# Product Change Notification

**Change Notification #:** 111544 - 00  
**Change Title:** Front Panel Spare FXXFPANEL  
PCN 111544-00, Product Design  
Changing Front Panel LED Brightness  
and Size of the Power Button  
**Date of Publication:** June 20, 2012

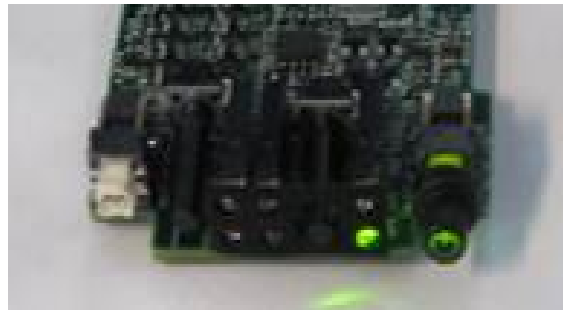
Changing the value of a resistor on the printed circuit board of FXXFPANEL and reducing the size of the power button to increase the brightness of the front panel LED light.
